**WARRANTY
BULLETIN**

Wb97-23

DATE: Oct. 1997	SECTION: 22
SUBJECT: INSIDE AIR TEMPERATURE SENSOR

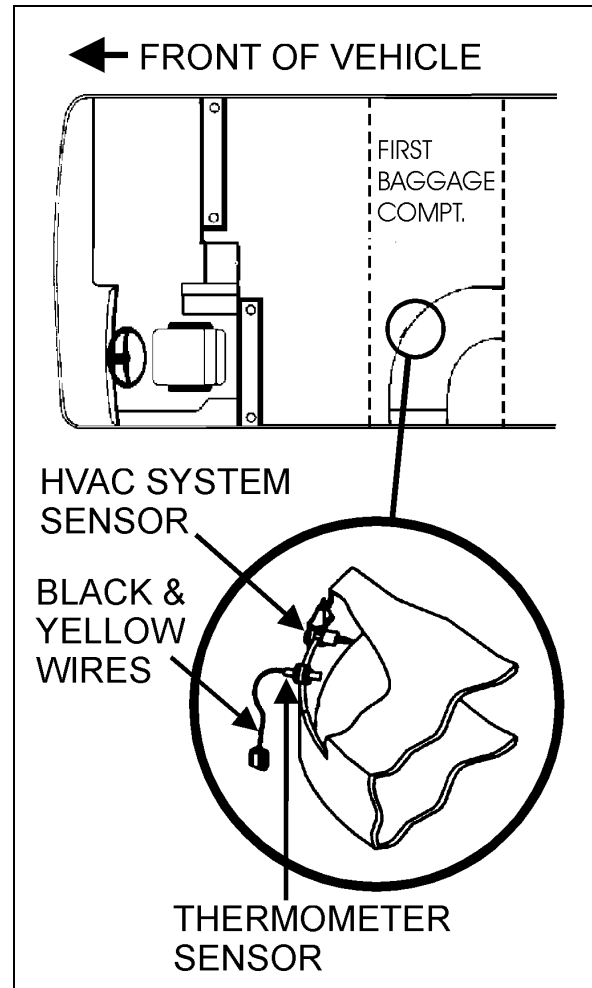
On the above-mentioned vehicles, the reading displayed by the inside air temperature thermometer may be incorrect by some degrees due to the location of its sensor. To remedy this situation, perform the following procedure.

1. Open L.H. side first baggage compartment door.
2. Locate the thermometer sensor mounted in ventilation duct (refer to figure).
3. Disconnect the thermometer sensor connector, then remove sensor from ventilation duct by pulling on both wires (black & yellow).

4. Enlarge sensor mounting hole using a 5/8" (16 mm) diameter bit.
5. Insert new thermometer sensor assembly (#453074) in duct, use a small flat screwdriver to introduce the small lip of the grommet inside the duct.
6. Connect thermometer sensor connector.
